Our Ref: 12025

27th March 2012

Re: Submission to Sydney CityGrid Project Major Project application No. SJ-06087 Stage 2A(ii) City East Zone Substation & Commercial Tower at 33-35 Bligh Street Sydney

North East Side Elevation

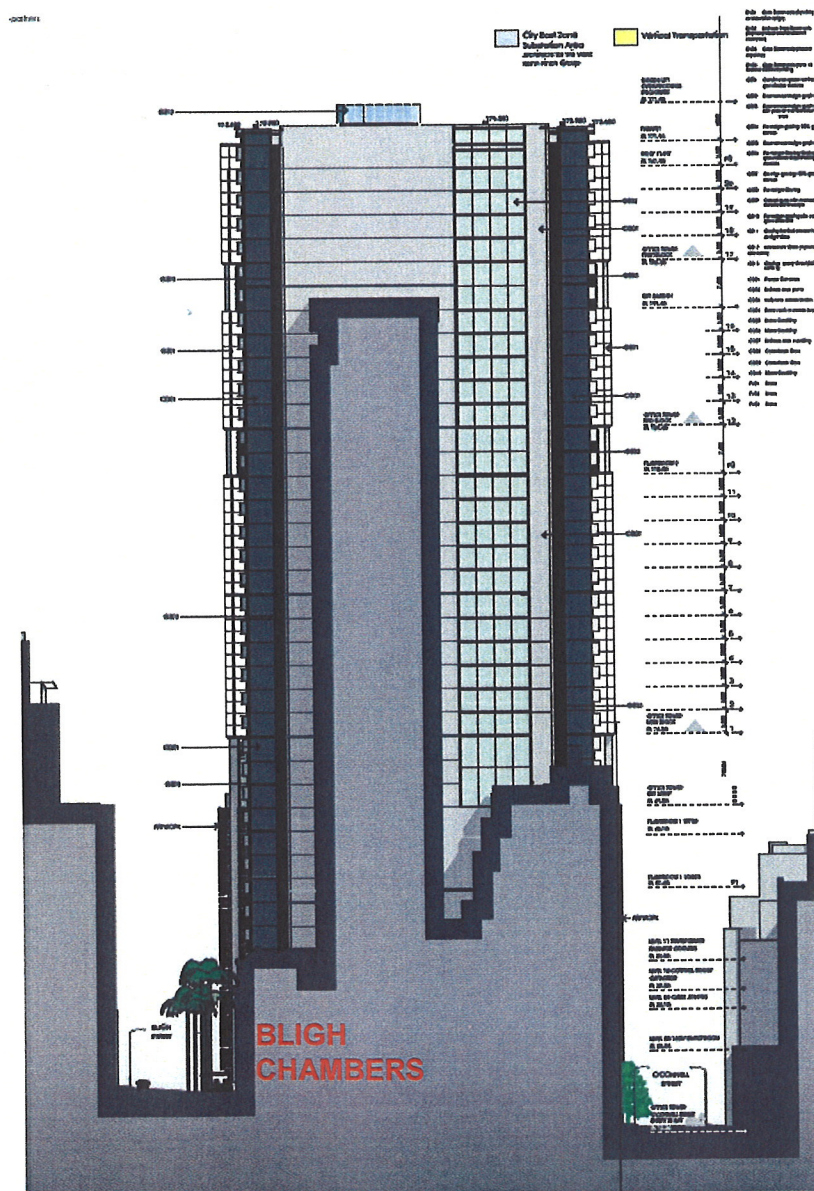
The following diagram from the proponent's Environmental Assessment Report clearly illustrates the excessive bulk of the proposed building. Our client's building, Bligh Chambers is a relatively large office tower, but is dwarfed in comparison to the proposed development and creates a canyon effect to Bligh Street and O'Connell Street. Inadequate front setbacks to the proposed tower, combined with narrow street widths, create an overbearing and canyon like effect at street level in Bligh Street and O'Connell Street.
